TD APPROVED AS NOTED

PROGRESS SET 03.22.16

PROJECT:
FREDERIKSTEDT REVITALIZATION PROJECT
PAUL E. JOSEPH BASEBALL STADIUM
AND SPORT COMPLEX

A1.10 FIELD LEVEL PART PLAN A
3/16/16

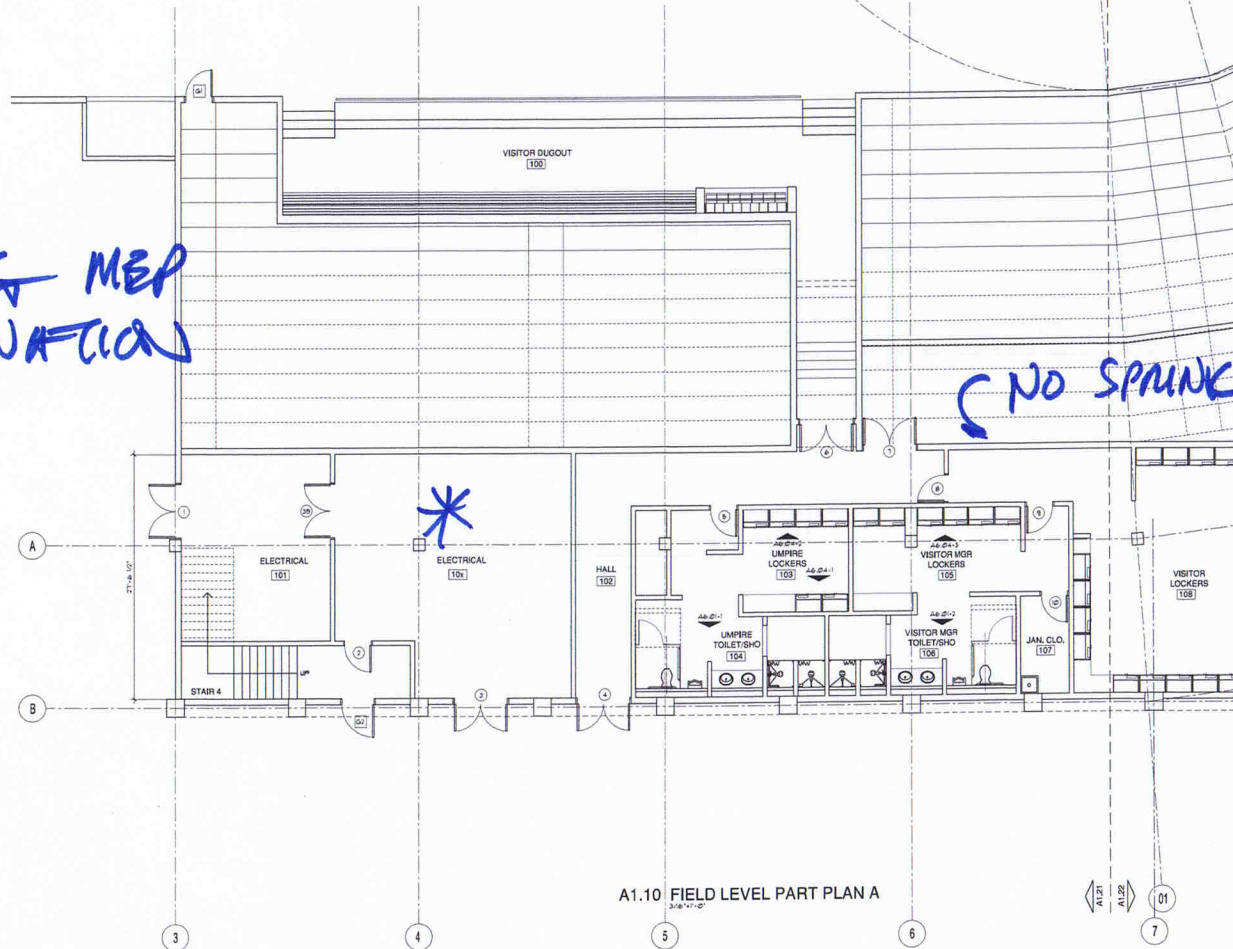
* PENDING MEP
COORDINATION

NO SPRINKLERS

ROOF STUDY A-1

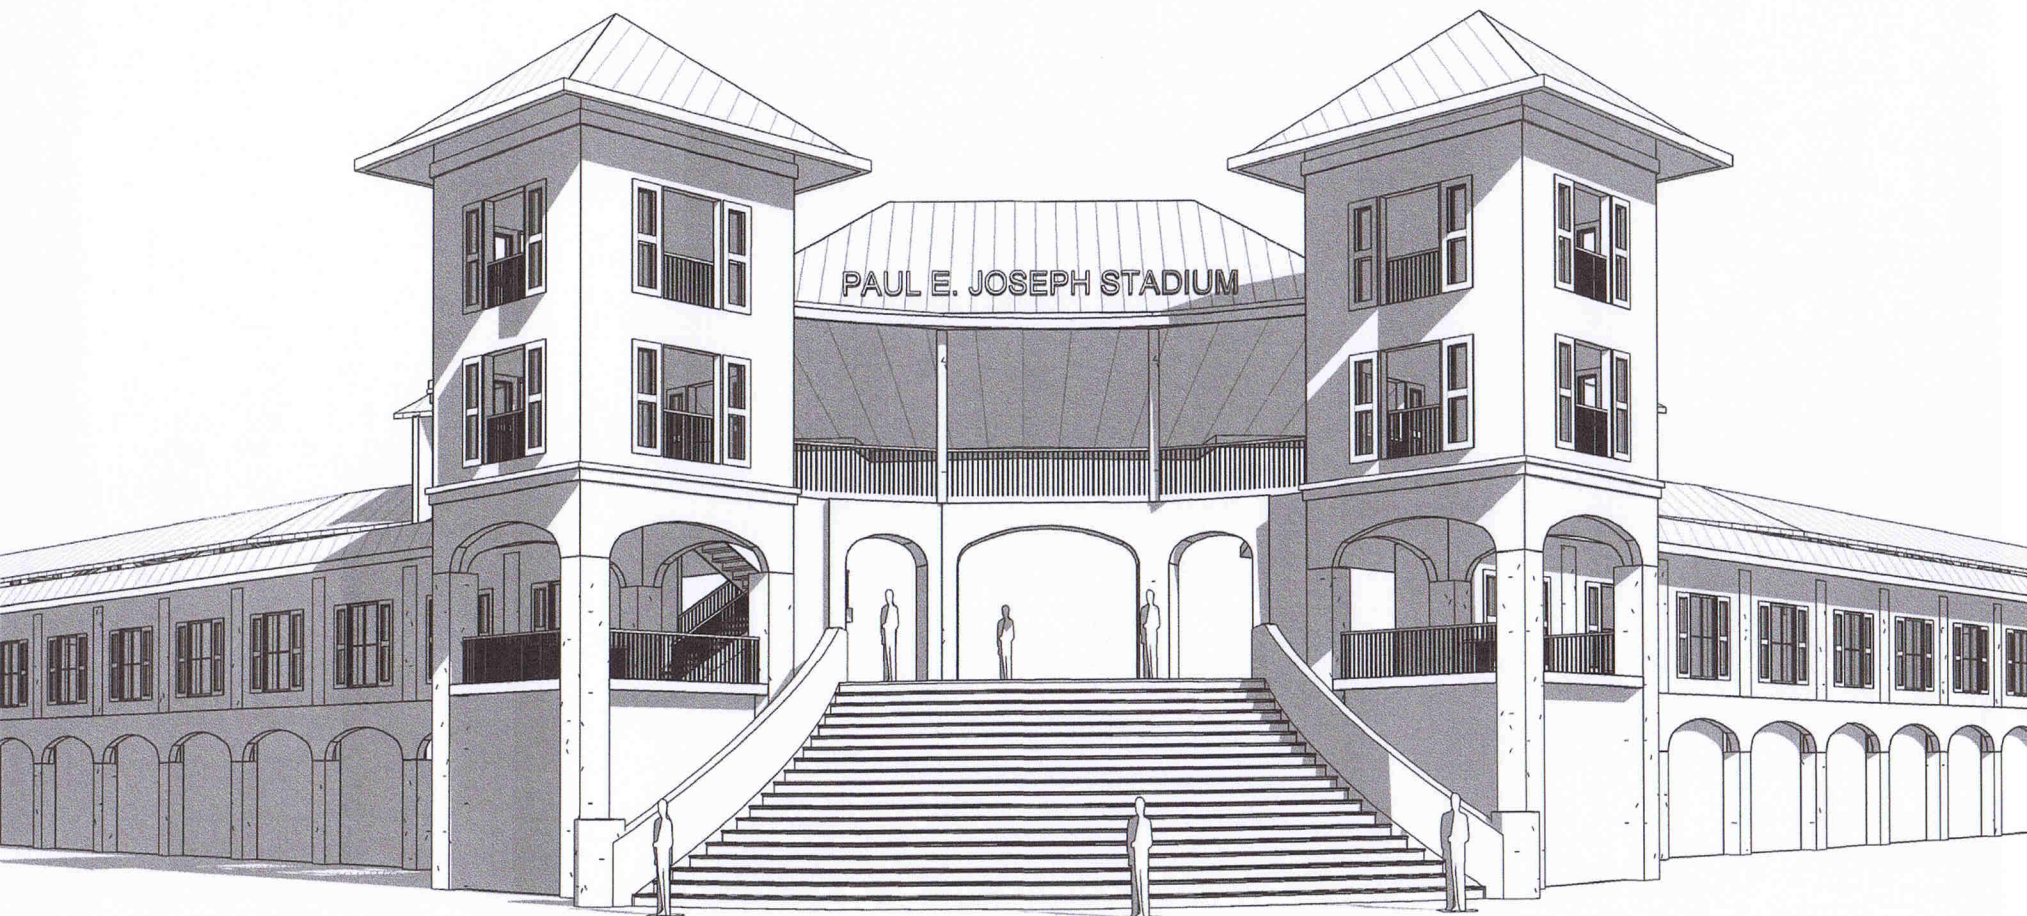
APPROVED EXISTING
(3) SIDED HIP.

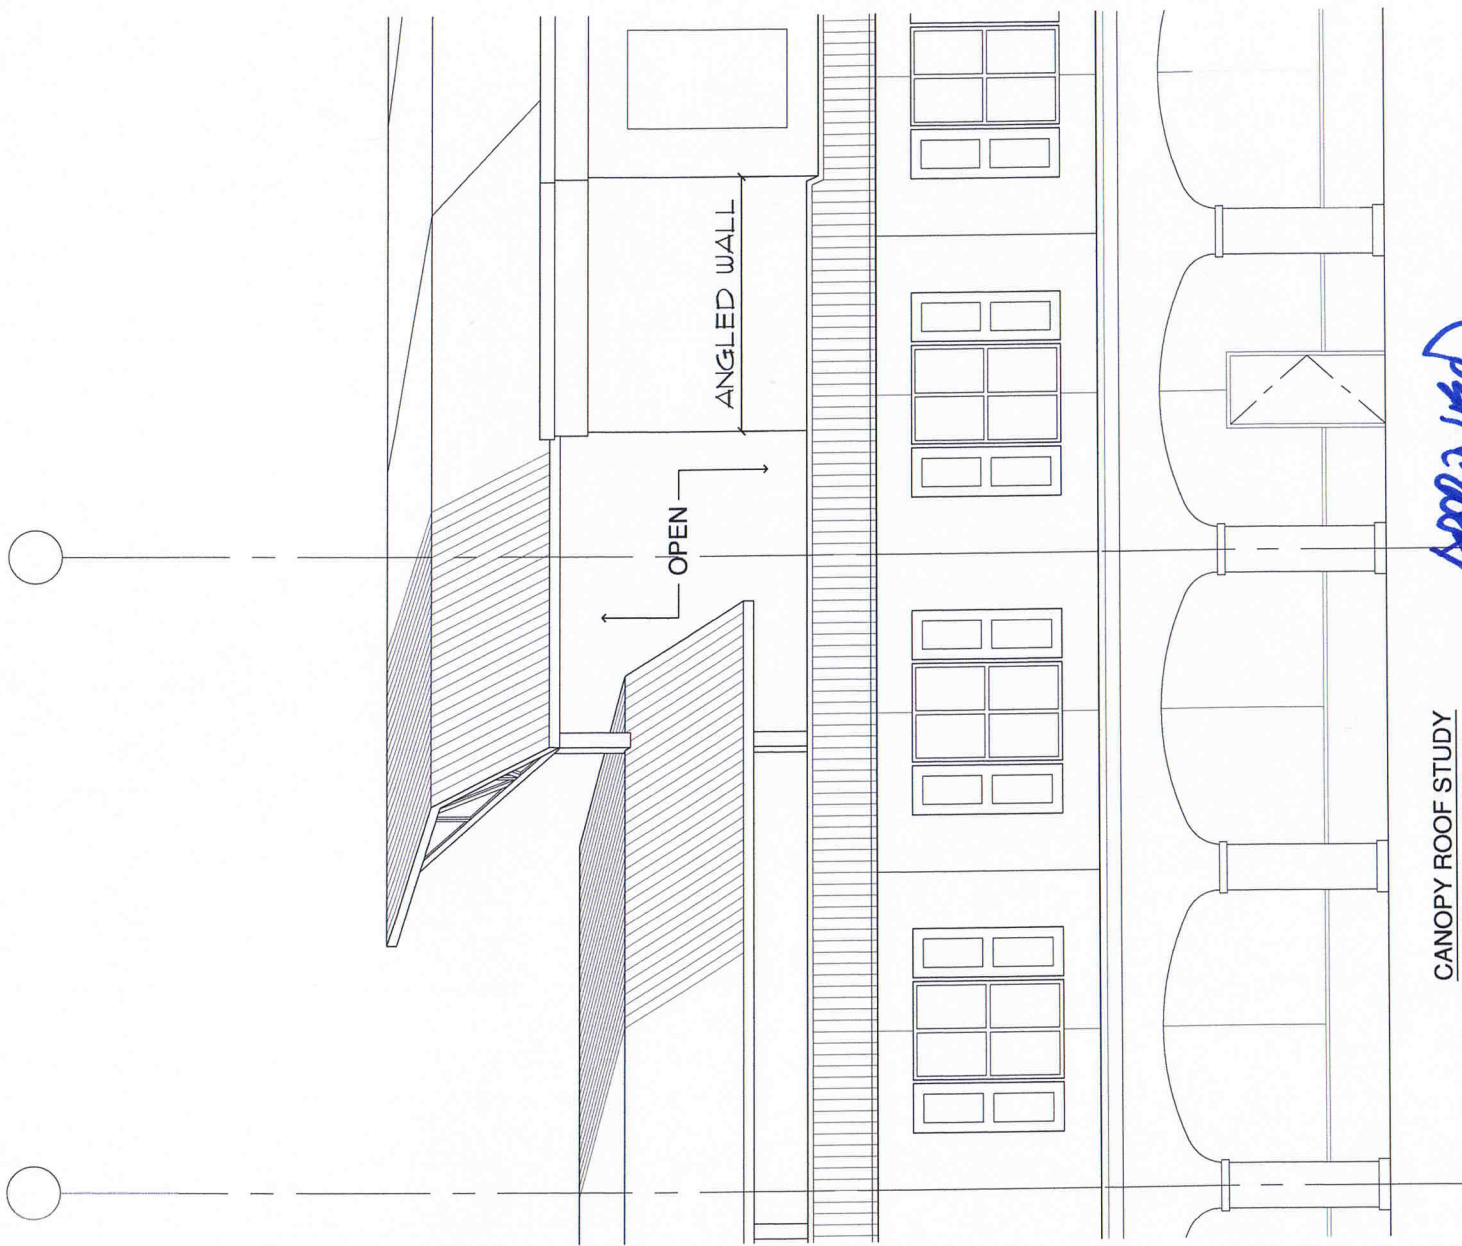
Approved
